# Symbology Standards Management Committee

Meeting Support Package  
May 6, 1999

<b>CHANGE PROPOSAL NUMBER</b>		<b>MIL98-04A</b>	
<b>ORIGINATOR</b>	<b>SPONSOR</b>	<b>DATE RECEIVED</b>	<b>DATE OF ACTION</b>
<b>PM FATDS</b>	<b>ARMY</b>	<b>3 FEB 1999</b>	<b>25 MAR 1999</b>
<b>CHANGE PROPOSAL TITLE</b>			
ADD NEW SYMBOL, SYSTEM RANGE FANS			
<b>SUGGESTED CHANGE</b>

Description: **Fire Support, Area, Weapon/Target Acquisition System Range Fans, Circular**

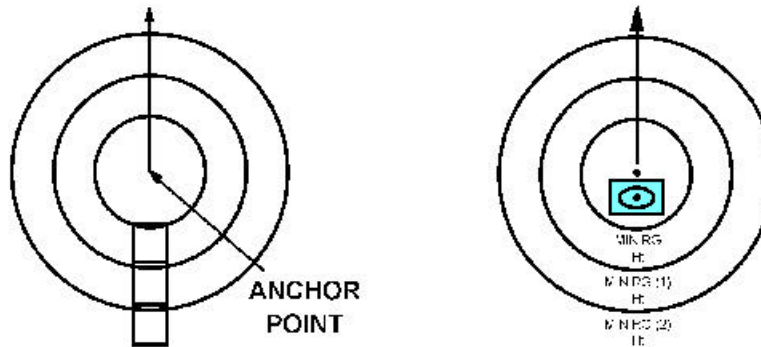
1. The purpose of the Range Fan symbol is to graphically display Fire Support weapon and Target Acquisition systems effective ranges to commanders in the Common Operational Picture (COP)/Common Tactical Picture (CTP).
2. Recommend adding to hierarchy item 2.X.4, Fire Support, under the "Areas" hierarchy, 2.X.4.3, figure B-17, and table B-IV.

1. **Anchor Points.** This graphic requires one anchor point that defines an object at a dynamic grid location. This coordinate, which pinpoints the current physical location of a specific unit, weapon or acquisition system, may change with the movement of the object. The symbol for that object is located at the anchor point.
2. **Size/Shape.** Shapes are concentric circles. Size is defined by the minimum and maximum ranges (as many as required) measured from the anchor point.
3. **Orientation.** The center point is typically centered over the known location of a weapon or target acquisition system. The orientation of the Circular Range Fan is the direction of engagement. The orientation may change as the object moves or changes.

**Label:** Text boxes will be used to label the minimum and maximum ranges and height of the range fan.

1. Revise table B-III, C2 Symbology: Military Operations symbol ID codes, to include the necessary information for the System Range Fan symbol.
2. Revise figure B-17, Fire Support, to include the System Range Fan symbols.
3. Revise table B-IV, C2 Symbology: Military Operations set, to include a generic and example symbol for both 2.X.4.3.11.1 and 2.X.4.3.11.2.

**Description:** Fire Support, Area, Weapon/Target Acquisition System Range Fans, Sector

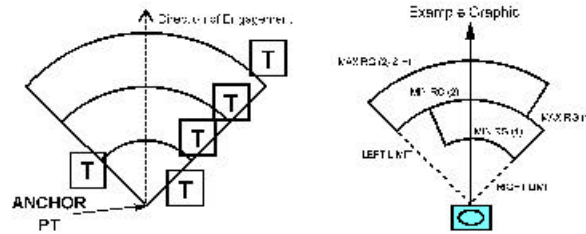
1. **Anchor Points.** This graphic requires one anchor point that defines an object at a dynamic grid location. This coordinate, which pinpoints the current physical location of a specific unit, weapon or acquisition system, may change with the movement of the object. The symbol for that object is located at the anchor point.
2. **Size/Shape.** Determined from the anchor point with a single azimuth that denotes Sector Center. The maximum left and right limits of the sector are measured from the sector centerline. Multiple ranges and/or maximum left and right limits of the sector, as well as height, may be entered, as required, to define the sector.
3. **Orientation.** The center point is typically centered over the known location of a weapon or target acquisition system. The orientation may change as the object moves or changes.

**Label:** Text boxes will be used to label the minimum and maximum ranges and maximum left and right sector limits and height.
